SUBJECT: INDIAN POINT NUCLEAR GENERATING UNIT NO. 2 - ISSUANCE OF
AMENDMENT RE: REACTOR VESSEL UPDATED HEATUP AND COOLDOWN
CURVES (TAC NO. ME0788)

Amendment No. 262
License No. DPR-26

SAFETY EVALUATION BY THE OFFICE OF NUCLEAR REACTOR REGULATION
RELATED TO AMENDMENT NO. 262 TO FACILITY OPERATING LICENSE NO. DPR-26
ENTERGY NUCLEAR OPERATIONS, INC.
INDIAN POINT NUCLEAR GENERATING UNIT NO. 2
DOCKET NO. 50-247

Figure 3.4.3-1:
Heatup Limitations for the Reactor Coolant System (RCS) and
Hydrostatic and Inservice Leak Testing Limitations for the RCS.

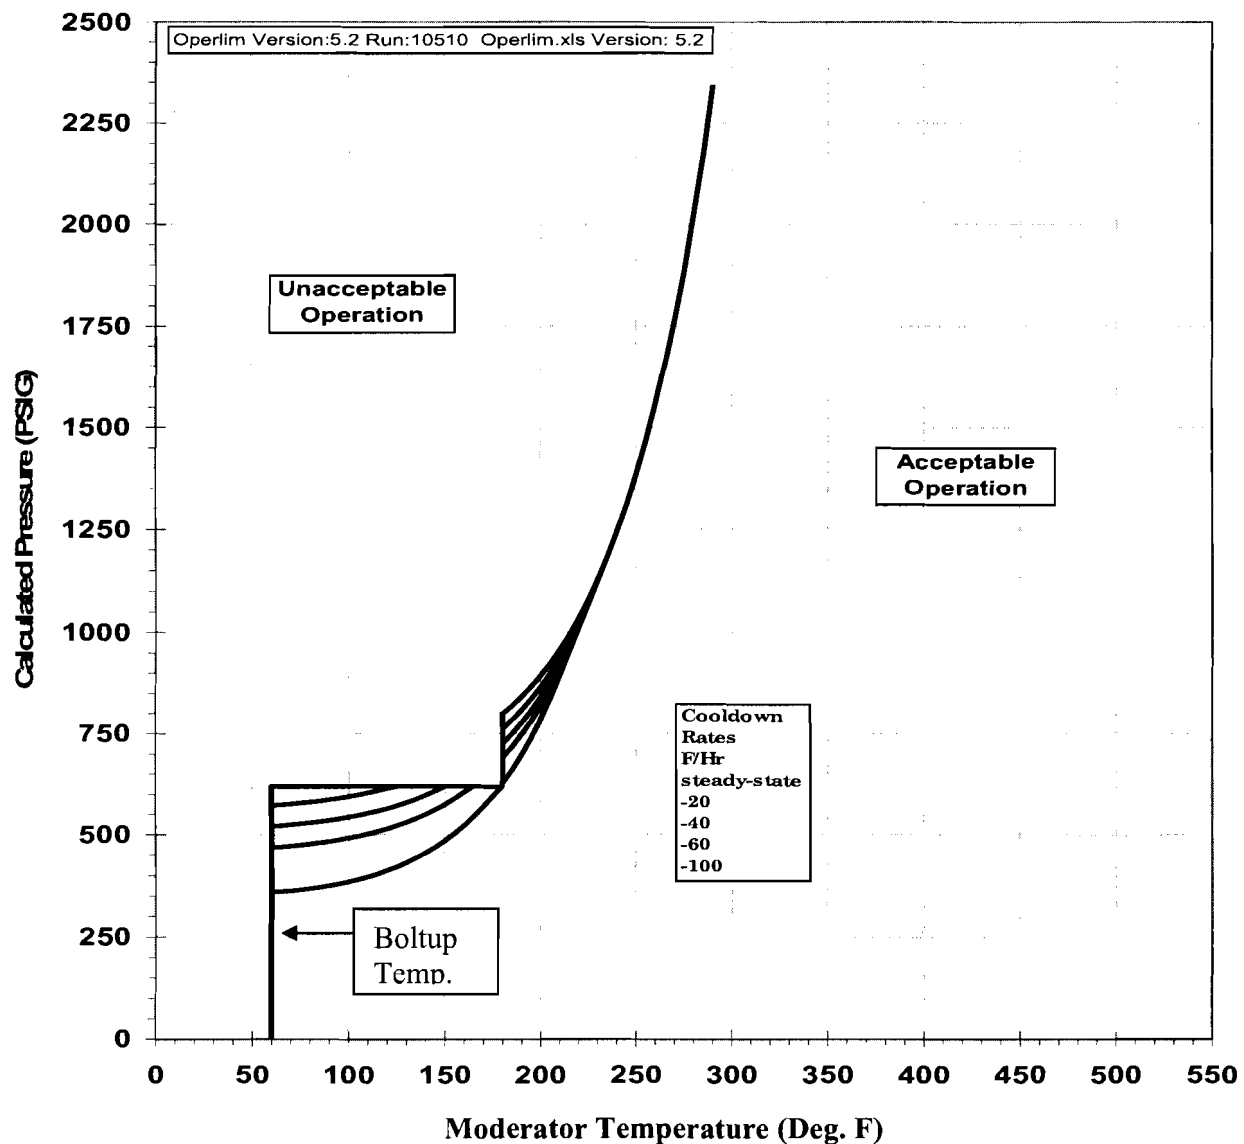
1. Acceptable operation is to the right of or below the applicable curve. Unacceptable operation is to the left of or above the applicable curve.
2. Figure 3.4.3-1 is effective until 29.2 effective full power years (EFPYs)
3. Figure 3.4.3-1 does not include any allowance for instrument uncertainty.

Figure 3.4.3-2:
Cooldown Limitations for the RCS (including RCS cooldown
following RCS inservice leak and hydrostatic testing)

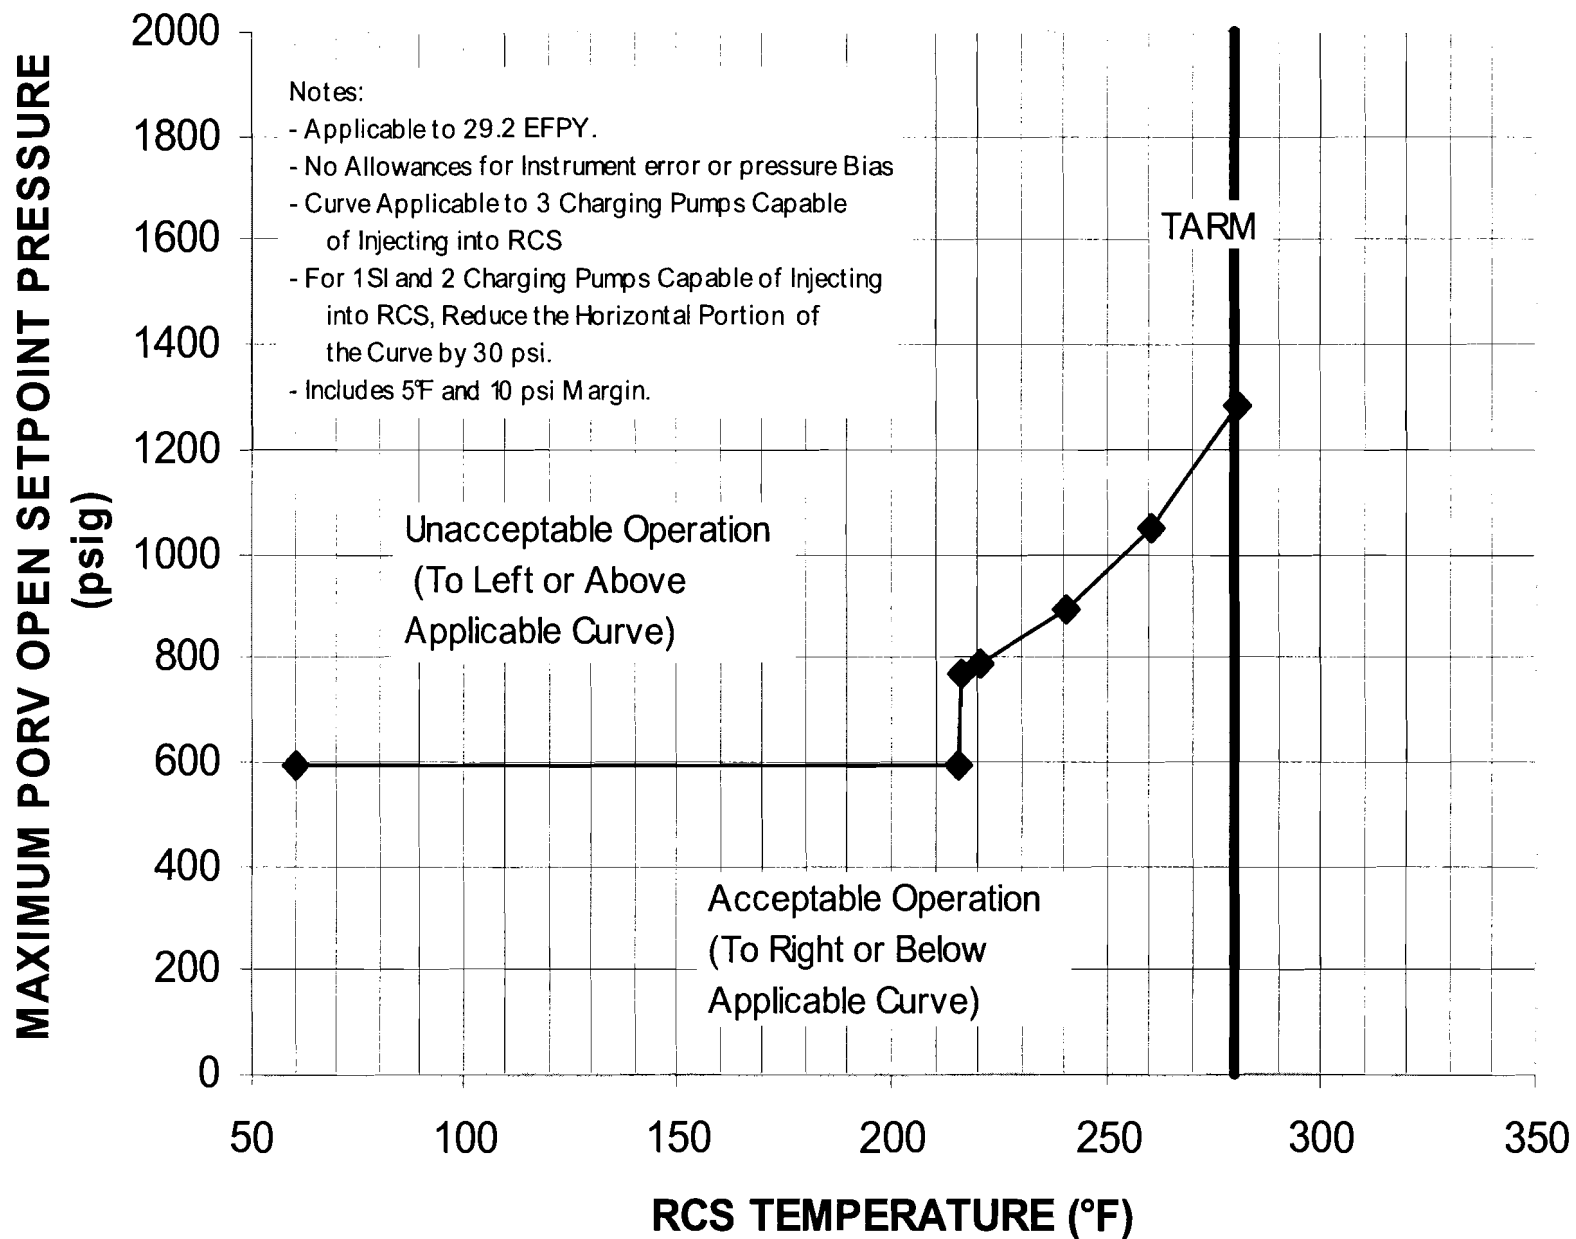
1. Acceptable operation is to the right of or below the applicable curve. Unacceptable operation is to the left of or above the applicable curve.
2. Figure 3.4.3-2 is effective until 29.2 effective full power years (EFPYs).
3. Figure 3.4.3-2 does not include any allowance for instrument uncertainty.

Figure 3.4.12-1: Maximum PORV Opening Setpoint as a Function of Temperature

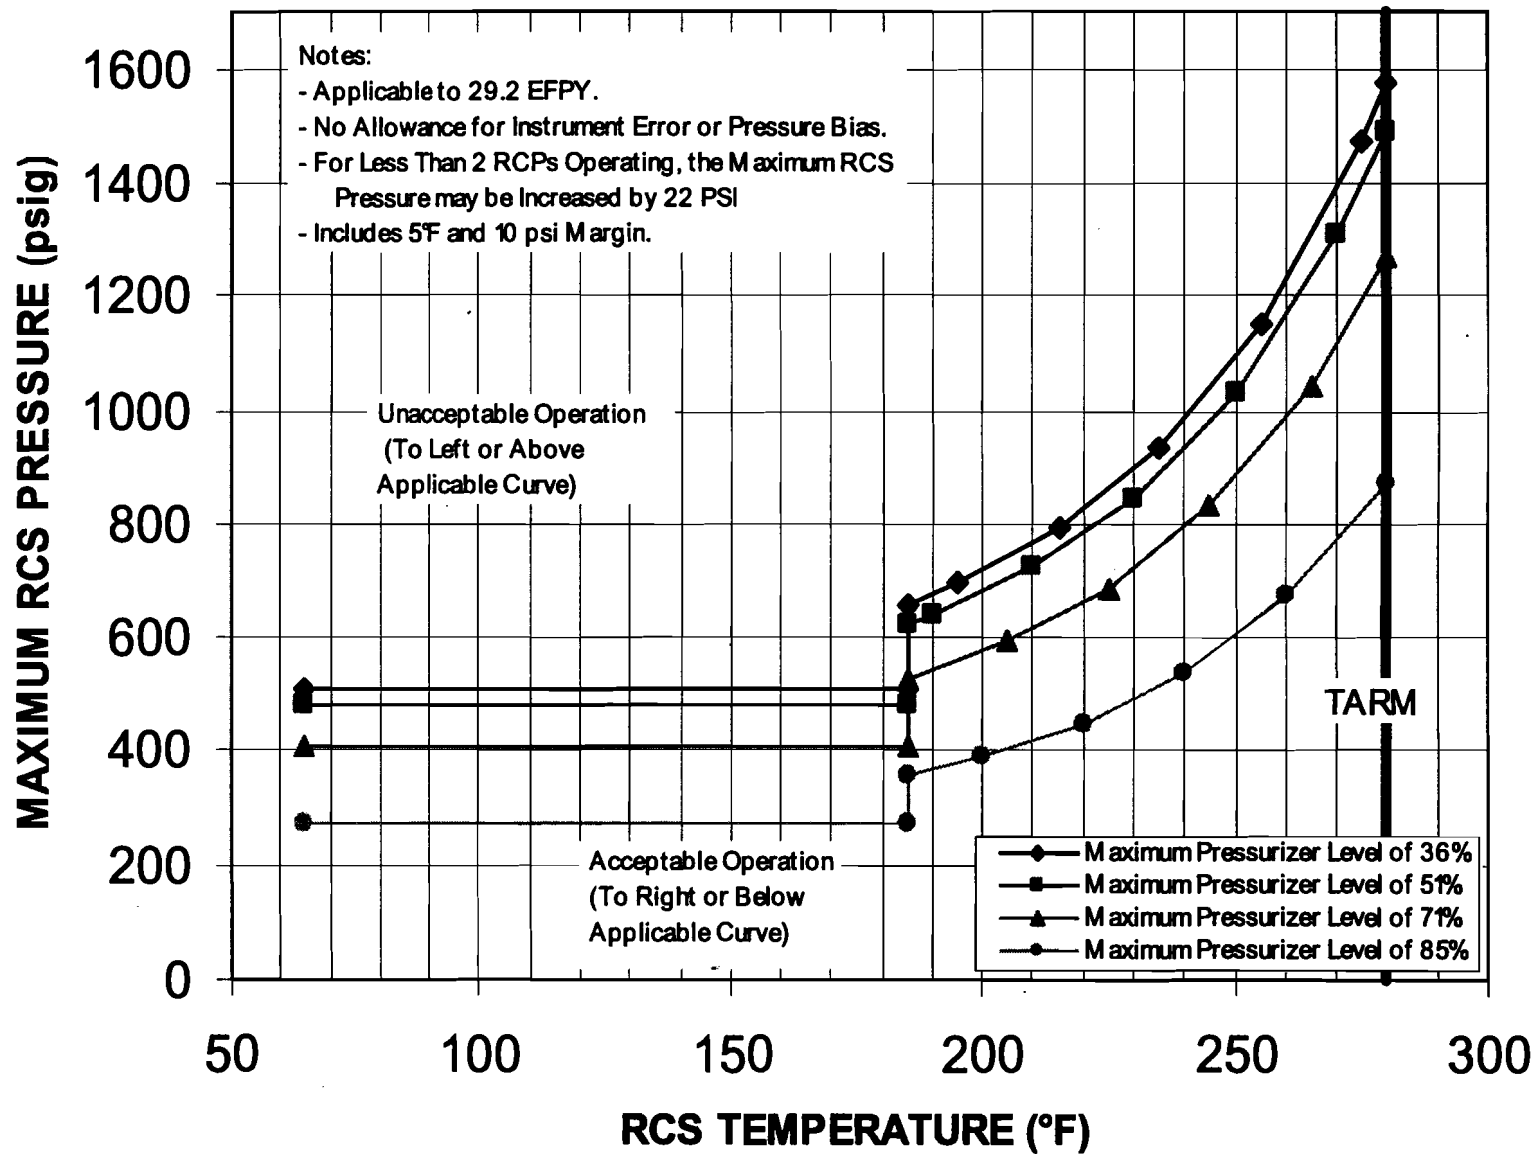
Safety Analysis Reports for Nuclear Power Plants.” Among other things unaffected by this license amendment request, BTP 5-2 recommends assuming single equipment failures and the analysis of multiple transients to establish the limiting transient. The licensee has followed the methodologies utilized in the development of the current P-T limits and LTOP requirements (for 25 EFPY). These methodologies were reviewed and accepted by NRC staff in the SE for TS Amendment No. 224, dated February 15, 2002 (ADAMS Accession No. ML020420477). The revised LTOP system setpoint, and associated LTOP system curves, reflect the increase in neutron fluence for a service life increase from 25 EFPY to 29.2 EFPY. The PORV opening setpoint is implemented as a variable setpoint for the LTOP system instrumentation.
